# TENDER NOTICE 5

## Serviced Apartments & Rear Carpark

<b>Attn:</b>	Premier Building & Construction c/o Anthony Baker	<b>Date:</b>	28.03.2025
<b>Address:</b>	abaker@premierbc.com.au		
<b>Client:</b>	Commercial Club Properties P/L		
<b>Project Address:</b>	652 – 660 Dean Street, Albury NSW 2640 512 & 526 Creek Street, Albury NSW 2640	<b>Project No.:</b>	2070
<b>Delivered By:</b>	Hand Delivery <input type="checkbox"/> Mail <input type="checkbox"/> Email <input checked="" type="checkbox"/>

Following the issue of documents on Monday 3<sup>rd</sup> March, we provide the following responses to questions raised:

DESIGN: C. SCHUTT	DRAWN: C. SCHUTT
CHECKED: C. SCHUTT	SCALE: AS INDICATED
PROJECT NO: E24160	DRAWING NO: S301

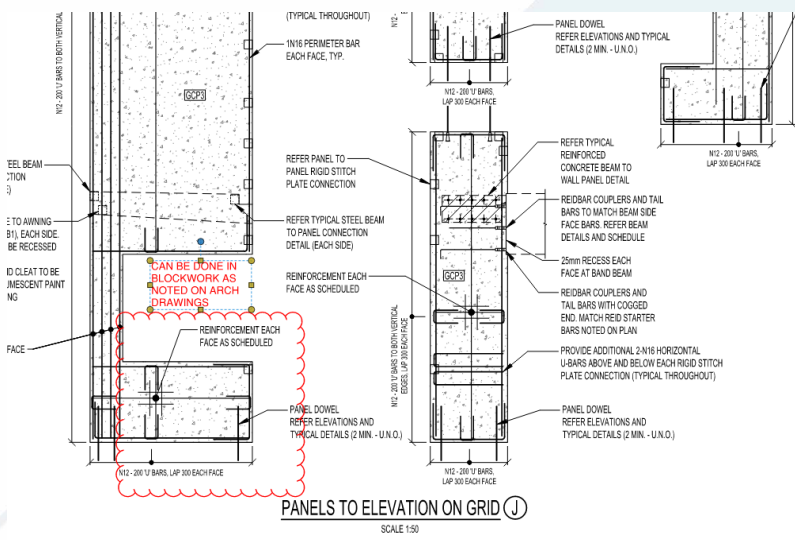
S301 – We note elevation on Grid J panel appears to be shown incorrect on the elevation but shown correct on the panel plan, please confirm?

See image below.
